Town of Parker Community Development Department
Development Review Division
Attention: **Stacey Nerger**

Application Type: **Replat**
Status: **First Referral**
Application Name: **Parker Auto Plaza F1 AMD 2**
Case/AP#: **SP20-018**
Referral Received: September 25, 2020
Comments Due: October 23, 2020

Review date: **September 30, 2020**
Plan reviewer: **Randall L. Capra, rcapra@parkeronline.org**
Phone: 303.805.3169

Narrative: The applicant is proposing a re-plat of Parker and Pine F1 Tract A and Parker Auto Plaza F1 Tract C to create a single buildable lot. The site is located southeast of Twenty Mile Road and Pine Lane.

Lot 1 – Bldg 1 & Lot 1 – Bldg 2:

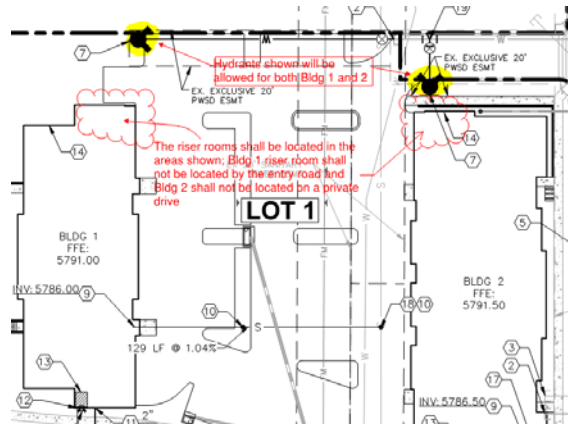
4. The location of the riser room for all three of the four proposed buildings is not acceptable; the applicant was provided with guidelines in as to approved locations in our pre-application meetings and as such, will be required

to revisit the submittal. Bldg 1 riser room location is not acceptable by the main entry and Bldg2 and Bldg 3 are not allowed to have the riser room located on a roadway... even if the access is a private road. Additionally, the applicant will need to identify the location of the fire sprinkler control valve room (more clearly showing its location), provide additional fire hydrants, and ensure the following: *Satisfied; applicant acknowledged/addressed with December 14, 2020 submittal response.*

- Exterior access is required into the riser room with access in the building provided either adjacent to the riser room or through the riser room. Access into the fire riser room shall not be through the volley ball court.
- The FACP will be required to be located in the fire sprinkler control valve room; ensure that the riser room is sized to accommodate the FACP and the riser. **A three-foot clearance is required in front of the FACP as well as the sprinkler riser.**
- The underground shall enter the building and turn up no further than 24 inches from foundation wall.
- The FACP shall be located on an interior wall.

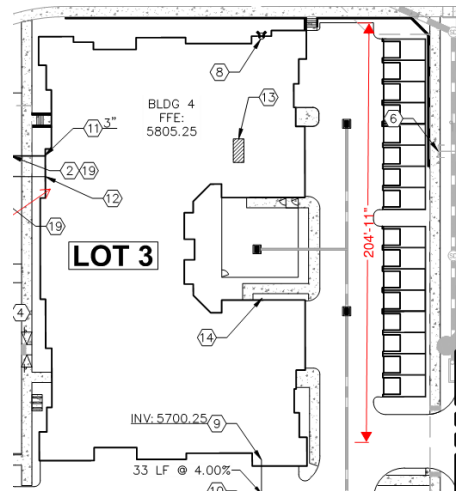
7. The applicant has provided an access road that exceeds 150' on the east side of Lot 3, Bldg 4; this access, as measured from the center line of the access perpendicular to this drive, is approximately 205 feet long. The applicant shall revisit the drive and configure the site to ensure that a dead end is not created that exceeds 150 feet, as required per [18 IFC 503.2.5]. Address this issue when resubmitting. *Satisfied; applicant acknowledged/addressed with December 14, 2020 submittal response.*
